CITY OF CONWAY, ARKANSAS HISTORIC DISTRICT COMMISSION

HISTORIC DISTRICT COMMISSION

April 28, 2025

A. Renovation & New Construction at 931 Faulkner St (HDR-0425-0054)

East Elevation

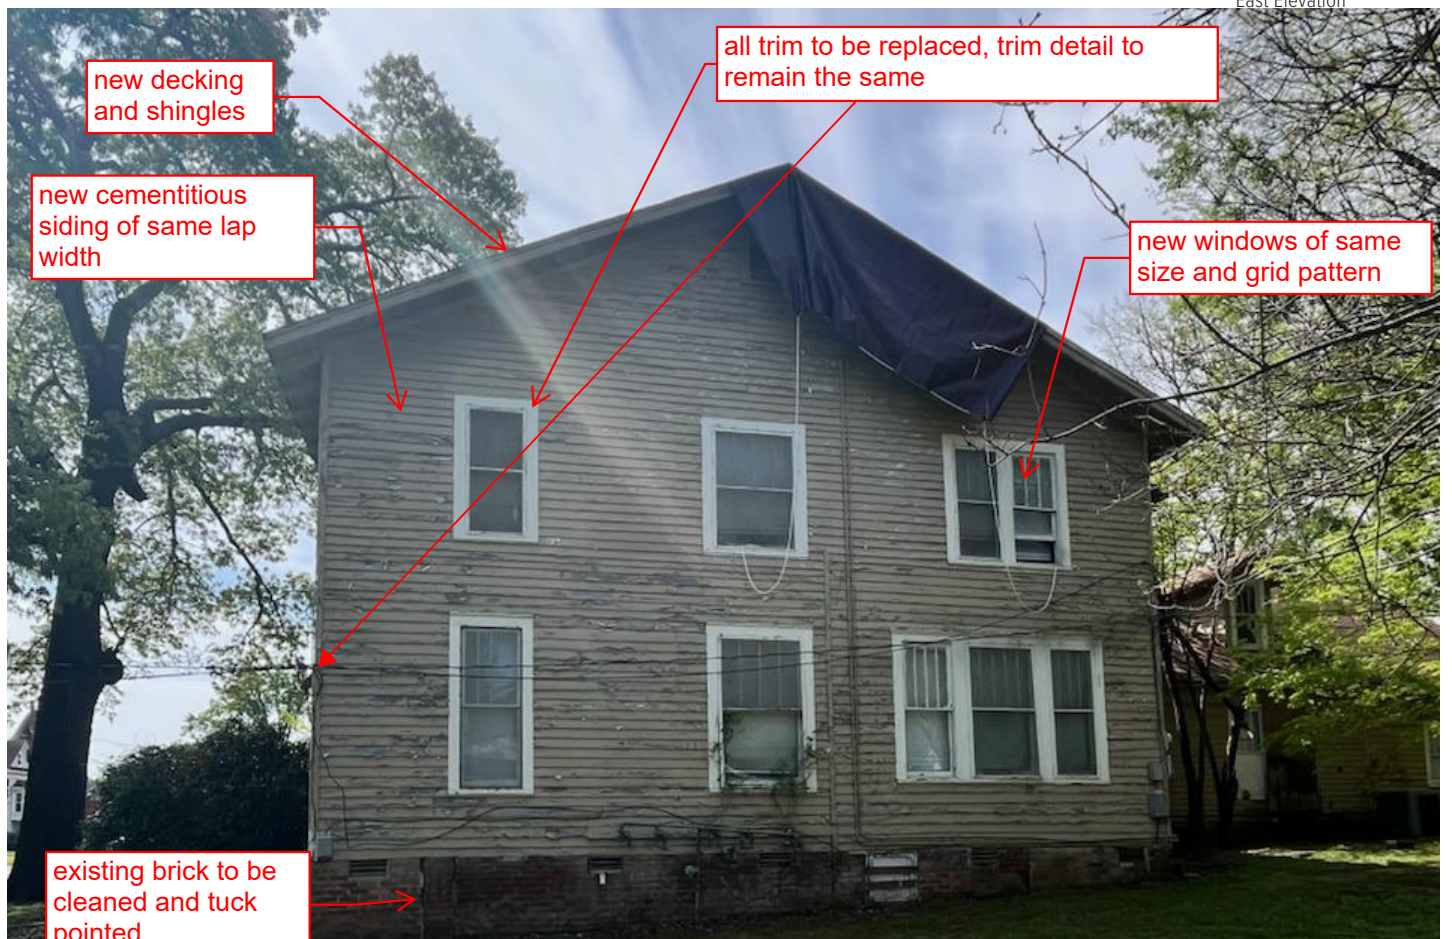
The proposed dwelling will be oriented towards a shared courtyard on 931 Faulkner and will be aligned with the existing structure. The front elevation may benefit from additional architectural details which would help it visually align with the Faulkner facades of adjacent buildings. This could be in the form of larger bottom floor windows, planter boxes, differing materials/textures, etc. The front door could be more pronounced to mitigate the orientation discrepancy. More details on other elevations should be considered, especially the southern elevation which is visible for northbound traffic on Faulkner St.

- Elevations that mitigate the new construction's orientation discrepancy on the Faulkner St façade.
- Additional architectural details on the Southern elevation.
- Courtyard entrance details (i.e. fencing type, vegetation, etc.).

FAULKNER SIDE-YARD
COURTYARD BUILDING & BLOCK
11/15/23

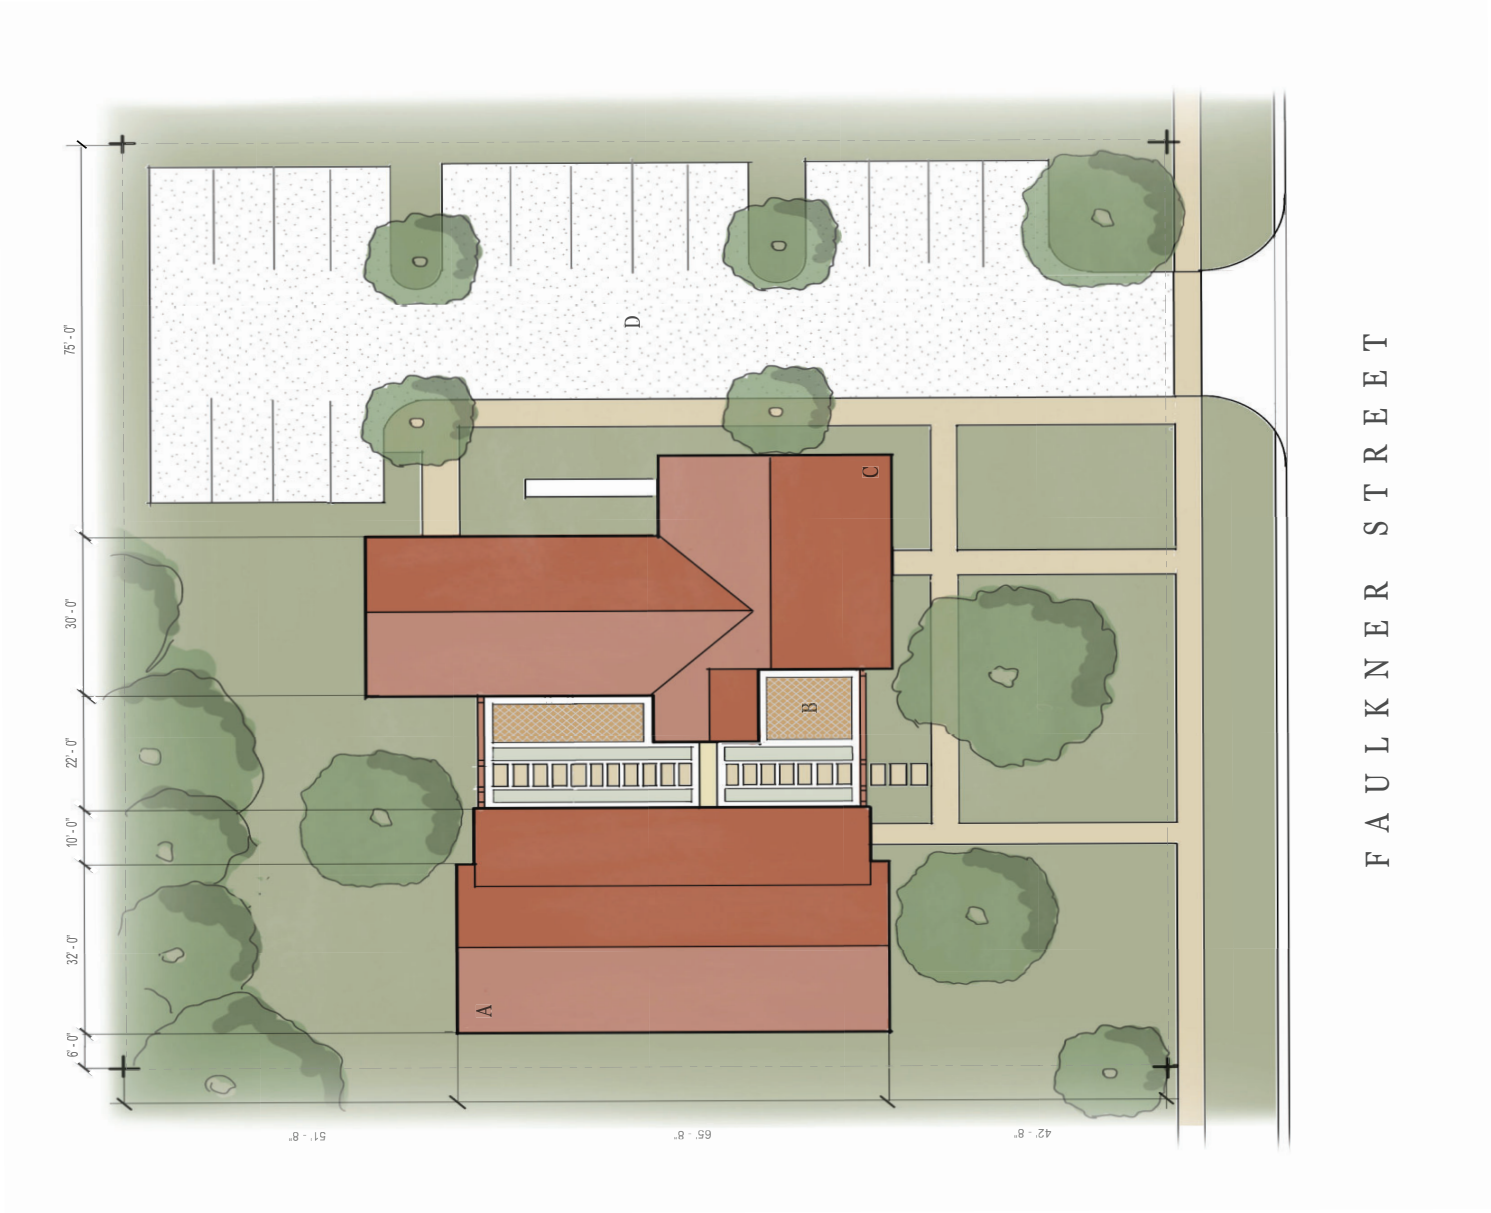
Parking is proposed to the north side of the development. The parking lot will be landscaped.

Walkways, Drives, & Parking. Design new walkways, driveways, and off street parking areas to be compatible in location, patterns, spacing, configurations, dimensions, materials and color with existing walkways, driveways, and off street parking areas that contribute to the overall historic character of the district. Location of parking areas should be at the rear of the property.
Some of the existing walkways will be repaired. Additional walkways are proposed. One driveway encroachment is proposed that leads to a proposed seventeen (17) spot parking area. The location of the parking area will necessitate the removal of six (6) significant trees. The parking lot is on the north side of the property. A parking lot at the rear would disturb the buffer between the dwellings and adjacent property, including the removal of trees at the rear of the property. The rear setback between the existing dwelling and the rear property line is approximately 30' which is insufficient for a parking area.

Asphalt is not a historic paving method and should not used for new driveways.
The proposed driveway and parking area must conform. The existing Southern driveway area should be removed.

3. Driveway and parking shall be composed of brick, stone, pavers, or concrete. Asphalt is not permitted.

8. Roofing shall be asphalt or composition type shingles.
9. Siding on the new construction shall be composed of brick and wood or a wood-like material such as Hardie® siding/LP® SmartSide®.
10. A minimum of five (5) trees from the approved species list must be planted along Faulkner St, outside of the right-of-way.
11. The existing sidewalk shall be repaired and meet ADA standards.
12. Lighting shall be inward, downward, and shrouded to stay within the bounds of the property.
13. The applicant shall coordinate with the Department of Transportation for a driveway permit.
14. The project shall undergo Site Development Review prior to building permit issuance.
15. The property shall be replatted prior to, or concurrently with, Site Development Review.
16. There shall be five (5) trees along the Faulkner St frontage.
17. Existing driveway shall be removed.
